STRATHFIELD LOCAL PLANNING PANEL MEETING AGENDA

TO: Strathfield Local Planning Panel Meeting - 2 February 2023
 REPORT: SLPP – Report No. 1
 SUBJECT: DA2021.233- 626-628 LIVERPOOL ROAD STRATHFIELD SOUTH
 LOT: 231 DP: 844782
 DA NO. DA2021.233

Property:	DA2021.233 626-628 Liverpool Road Strathfield South Lot: 231 DP: 844782
Proposal:	Demolition of the existing structures and tree removal, construction of building containing five (5) industrial units and a five (5) storey hotel with a pub on the ground floor above two (2) levels of basement (comprising a retail premises and parking) and installation of associated signage.
Applicant:	Hamptons Property Services Pty Ltd
Owner:	Iris Hotels Enfield Property Pty LTD ATF Iris Hotels Enfield Property Trust
Date of lodgement:	17 September 2021
Notification period:	24 September 2021 to 16 October 2021
Submissions received:	1
Assessment officer:	G I Choice
Estimated cost of works:	\$31,438,390.00 (Including GST)
Zoning:	B6-Enterprise Corridor - SLEP 2012
Heritage:	Proximity to I220: Weston Milling - NB Love building and administration block - old flour mill and administrative building - 22–28 Braidwood Street

Figure 23: Proposed signage plan (east elevation)

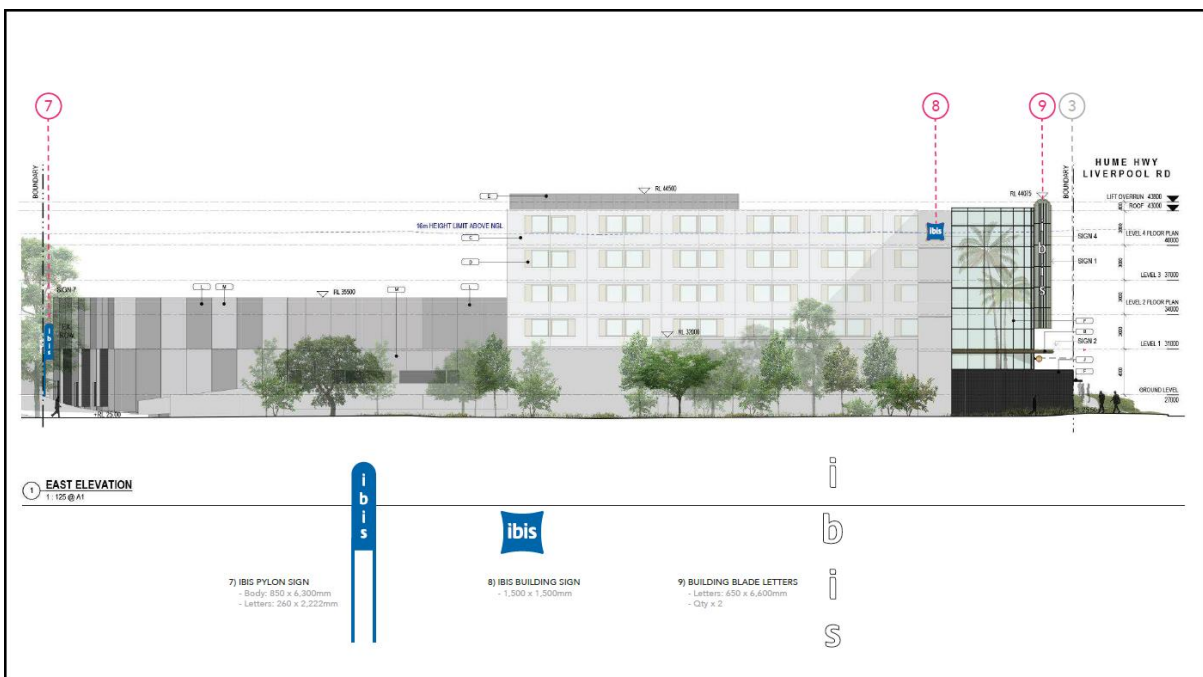
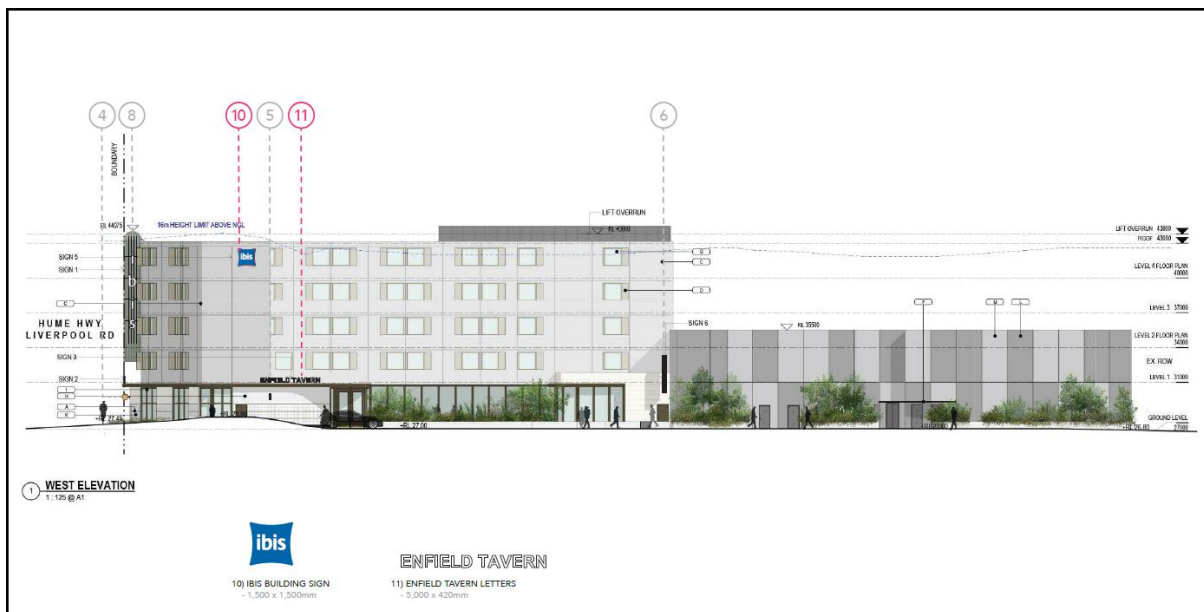
- (d) The proposed development is considered unacceptable pursuant to the provisions of s4.15(1)(a)(i) of the *Environmental Planning and Assessment Act 1979* as it fails to meet the objectives for the Maximum Building Height under Clause 6.6 of the Strathfield Local Environmental Plan 2012. The proposed above awning signage is prohibited within the Strathfield LGA.

- (a) The proposed development is considered unacceptable pursuant to the provisions of s4.15(1)(a)(iii) of the *Environmental Planning and Assessment Act 1979* as it fails to meet the aims of Part J (Advertising Signs and Structures) of the Strathfield Consolidated Development Control Plan 2005. The proposed above awning signs are prohibited with Strathfield LGA.

Figure 26: Proposed TPZ & SRZ plan

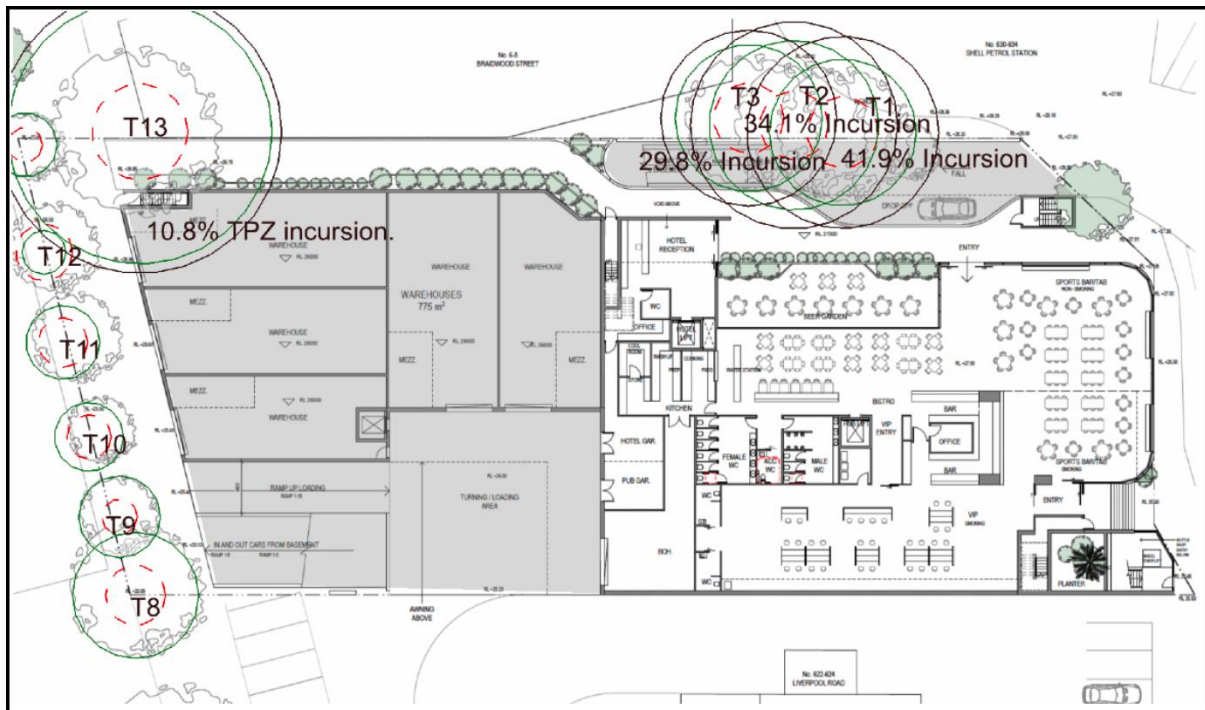
- 1. The location of neighbouring vegetation [must] be assessed by an AQF5 Arborist to see if they can be retained during the proposed demolition and construction of the site.*
- 2. If the vegetation cannot be retained during demolition and construction, consent from owners for their removal is required and new replacement plantings are required as part of the final landscape works for the site.*
- 3. One tree is highlighted to be retained (see attached Landscape Plan) this has not been addressed in the arborist report.'*

- (b) The proposed development is considered unacceptable pursuant to the provisions of s4.15(1)(a)(iii) of the *Environmental Planning and Assessment Act 1979* as it fails to meet the aims of Part O (Tree Management) of the Strathfield Consolidated Development Control Plan 2005. The proposal has not considered impacts to existing trees on adjoining properties.

Figure 29: Approximate transfer paths loading/unloading to warehouses

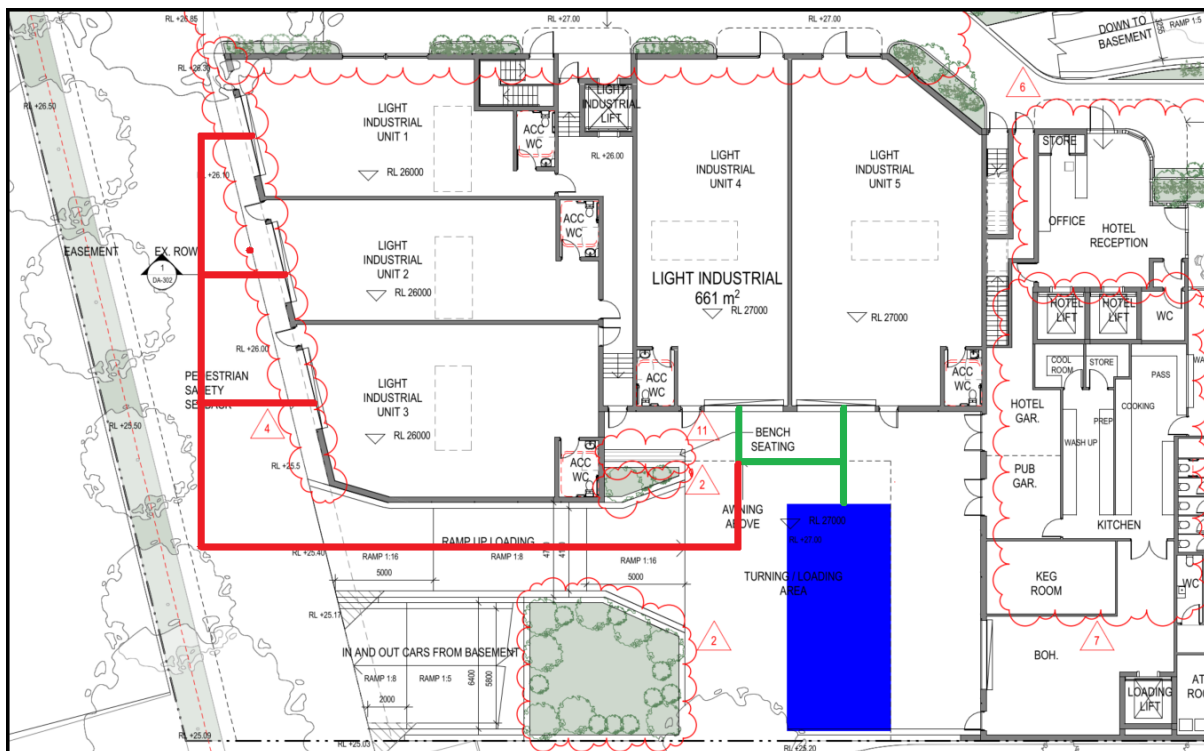
The proposed interface between the rear warehouse development and the and the private road at the rear of the site was identified as a key issue by the DRP (as discussed elsewhere in this report). The current design of the garage doors for Light Industrial Units 1, 2 and 3 does not have direct off-road access from the proposed loading dock to the said warehouses. This presents safety conflicts for vehicles/trucks reversing out of the units, forklifts traffic and transfers from the loading area to the rear warehouse as well as safety conflicts between pedestrians and vehicles using the shared road. The additional 1m setback does not adequately address this issue (see **Figure 29**).
